Groundwater Application Review Summary Form

Application # G- 19288

TO: Water Rights Section Date 9/11/2023
 FROM: Groundwater Section Grayson Fish
 Reviewer's Name
 SUBJECT: Application G- 19228 Supersedes review of _____
 Date of Review(s)

A. GENERAL INFORMATION: Applicant's Name: McKoen Family Trust County: Klamath

Water-Level Measurements in Nearby Wells

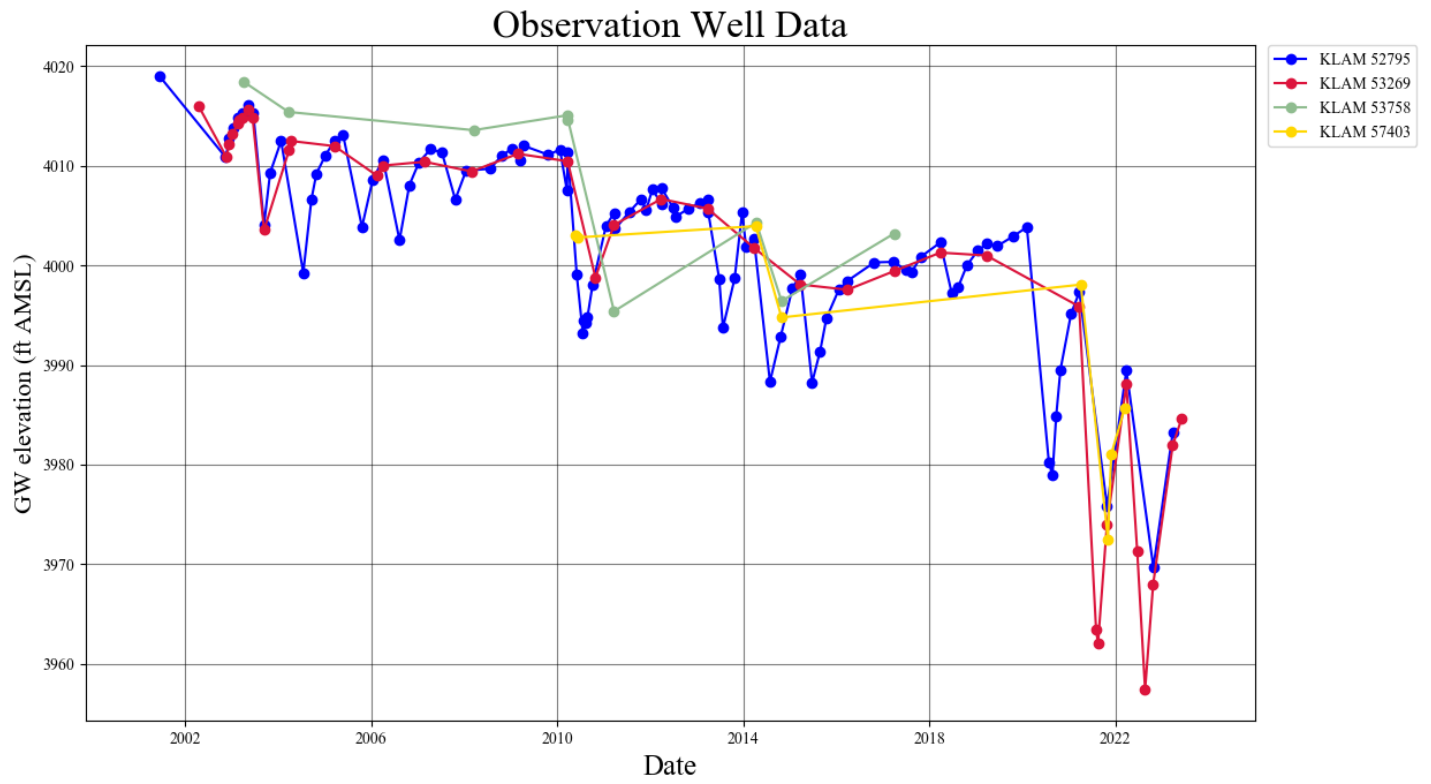
B3. **Groundwater availability remarks:** The applicant’s proposed POA is in an area where water levels have been observed to have declined over 30 feet since 2001 with approximately 20 feet of decline occurring since 2020 alone. There are several existing water rights in the immediate vicinity of the proposed POA that have permit condition requiring discontinued or reduced use if water level records show 25 ft or more decline. If additional water use were to be allowed under this proposed right, that use would have the potential to contribute to declines and lead to permit conditions being triggered on existing rights. **This would preclude the perpetual use of the aquifer by limiting the rights of existing users , therefore, new additional use (volume) would not be within the capacity of the resource.**

Given the relatively high transmissivity and thickness of the volcanic rock/sediment aquifer the proposed POA sources water from, use from this well at the requested rate would be unlikely to result in injury to nearby senior water rights. If this right were to be approved, the conditions in B1(d)(i) should be applied.
